Site Accessibility Evaluation

Rudy Park

Accessibility Evaluation

SUBJECT: Rudy Park Self-Evaluation

Finding: 1

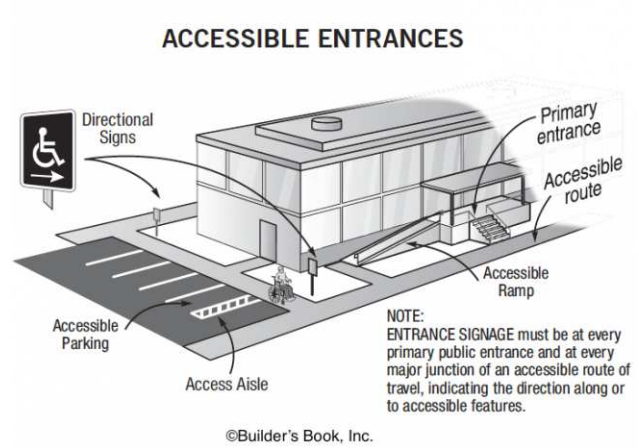
There is no accessible route of travel from the public way.

There is not a curb ramp from the street parking on Cracker Barrell Cir.

Install a curb ramp near the path into the park off of Cracker Barrell Cir.

Finding: 2

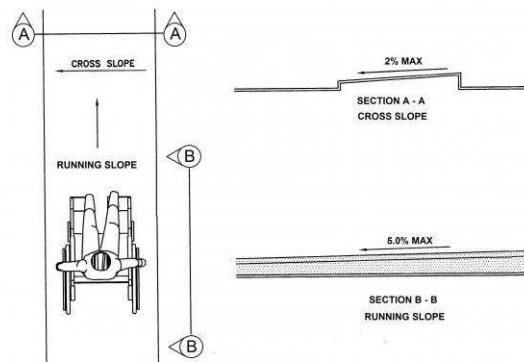
The accessible path of travel has cross slopes greater than 2%.

The sidewalk down Cracker Barrel Cir has 51 pads of concrete with excessive cross-slope measuring as high as 6%. This stretch of sidewalk also has a high running slope throughout, however, it follows street grade and therefore meets compliance. 29 pads are at or exceed 3% cross slope.

Remove and replace pads with high cross slope to compliance.

Finding: 3

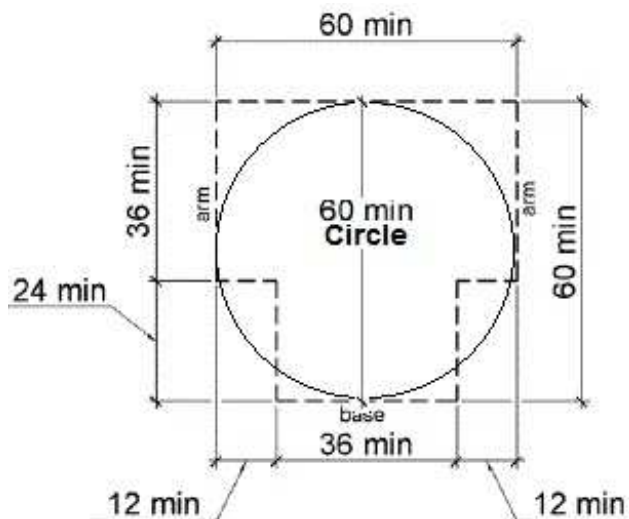
The T-shaped or circular turning space has excessive slopes.

This turn at the entrance to the park has a slope of 4.9%.

Remove and replace concrete at this turn to compliance.

Finding: 4

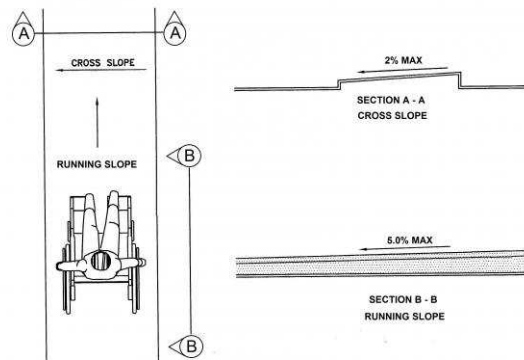
The accessible route has running slopes greater than 5% and has not been constructed as a ramp (i.e. handrails, edge protection, etc.). Cross slopes are greater than 2% across the width of the walk.

The path into the park, just north of the baseball field, that connects to the Homestead Trail in the northeast corner of the park, has 31 pads of concrete with excessive cross slope and/or running slope. There are 29 pads with a high cross slope measuring up to 5.2%. 14 of the pads are at or over 3% cross slope. There are 13 pads with a high running slope of up to 9%. 4 pads exceed 8.33%.

Remove and replace the pads with a high cross slope. The terrain is such that it may not be feasible to achieve a compliant running slope.

Finding: 5

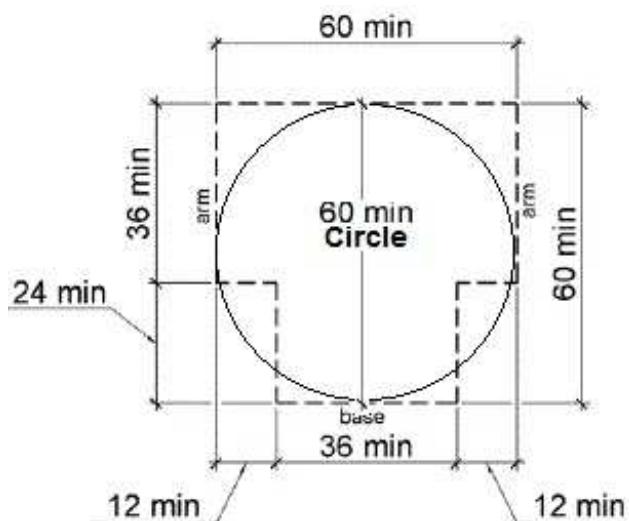
The T-shaped or circular turning space has excessive slopes.

This turn at the top of the path into the park, where it forks in two directions to the Homestead Trail, has a slope of 6.5%

Remove and replace concrete at this turn to compliance.

Finding: 6

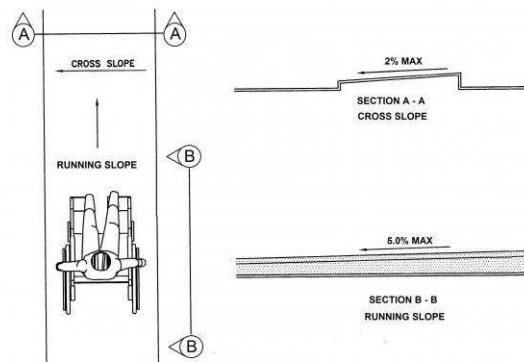
The accessible route on the site has running slopes greater than 5 percent and has not been constructed as a ramp (i.e. handrails, edge protection, etc.).

This stretch of the route that connects the route into the park to the Homestead Trail (the north route) has six pads of concrete with a high running slope measuring as high as 6.4%.

Do nothing as it is not feasible to achieve compliance running slope here given the terrain.

Finding: 7

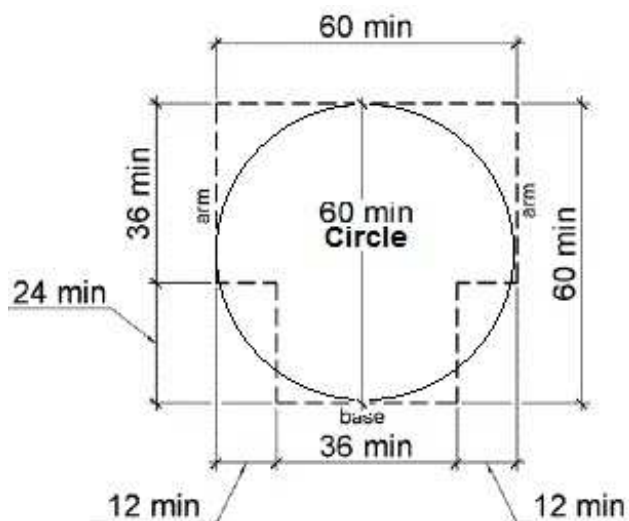
The T-shaped or circular turning space has excessive slopes.

This turn where the park route connects to Homestead Trail (the north connector) has a slope of 3.6%.

Remove and replace concrete at this turn to compliance.

Finding: 8

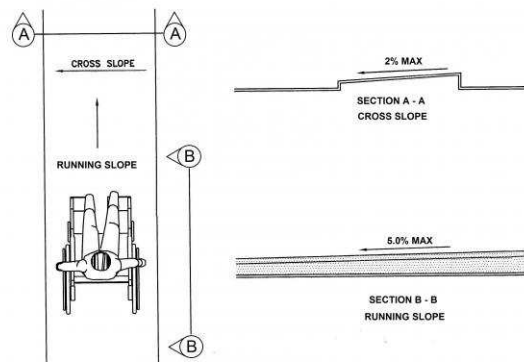
The accessible path of travel has cross slopes greater than 2%.

This stretch of path that connects the main route into the park to Homestead Trail has five pads of concrete with high cross slope ranging from 3.3% to 4.3%.

Remove and replace concrete to compliance.

Finding: 9

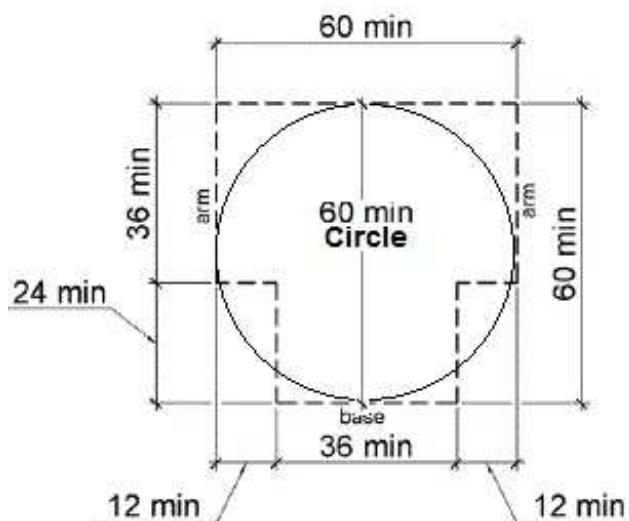
The T-shaped or circular turning space has excessive slopes.

This turn where the park route connects to Homestead Trail (the south connector) has a slope of 4.6%.

Remove and replace concrete at this turn to compliance.

Finding: 10

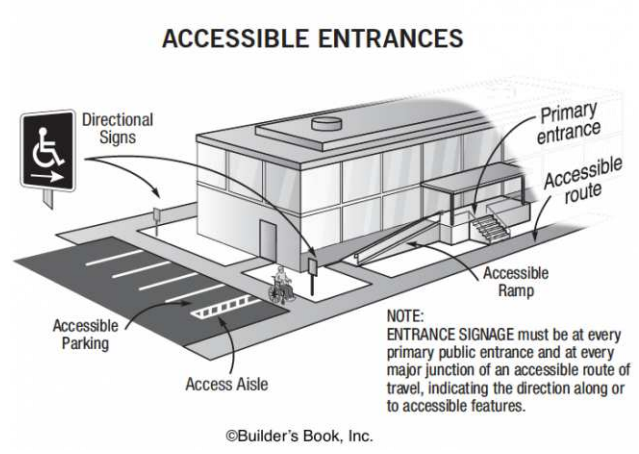
There is no accessible route to the element.

There is no accessible route to the baseball field.

Create an accessible route from the path into the park to the backstop seating area of the baseball field.
